Access Compliance Report

Public Rights-of-Way

Intersection ID: 6766	Main Street: INDIAN RIDGE LN	Cross Street: WINDING CANYON DR	Location: S
ADA ID: 653C77A2D645	Ramp Type: Perpendicular Diagonal	Initial Pass/Fail: Fail	Overall Compliance: No
			Severity Score: 13.75

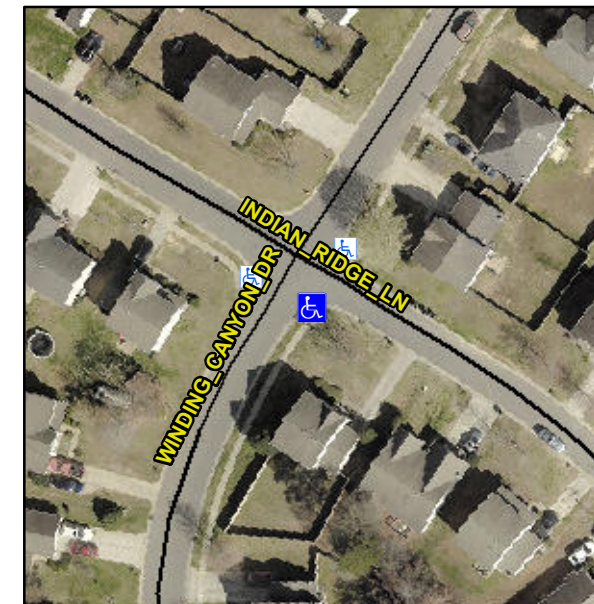
Not Found, R304.2.2, R304.5.3

Compliance	Description	Data	Compliance	Description	Data
N/A	Ramp Length (in)	49.5	No	Ramp Slope (%)	9.5
Yes	Ramp Width (in)	48.0	No	Ramp XSlope (%)	3.1
N/A	Flare Type LT	N/A	N/A	Flare Type RT	N/A
N/A	Flare Slope LT (%)	N/A	N/A	Flare Slope RT (%)	N/A
N/A	Flare Traversable LT?	N/A	N/A	Flare Traversable RT?	N/A
N/A	Landing Length (in)	N/A	N/A	DWS Provided?	N/A
N/A	Landing Width (in)	N/A	N/A	DWS Contrast?	N/A
N/A	Landing Slope (%)	N/A	N/A	DWS Length (in)	N/A
N/A	Landing X Slope (%)	N/A	N/A	DWS Full Width?	N/A
N/A	Landing Curb? (Y/N)	N/A	N/A	DWS Offset (in)	N/A
N/A	Shared Landing?	N/A			
N/A	Gutter Ponding?	N/A	N/A	Gutter Slope (%)	N/A
N/A	Gutter Lip Ht (in)	N/A	N/A	Gutter X Slope (%)	N/A
N/A	Painted X Walk1?	No	N/A	Painted X Walk2?	No
	X Walk 1 Direction	To NE		X Walk 2 Direction	To NW
N/A	X Walk 1 Width (in)	N/A	N/A	X Walk 2 Width (in)	N/A
	X Walk 1 Slope (%)	2.7		X Walk 2 Slope (%)	2.9
	X Walk 1 X Slope (%)	1.8		X Walk 2 X Slope (%)	2.0

Remove & Replace Curb Ramp With Two New Directional Ramps or Equivalent.
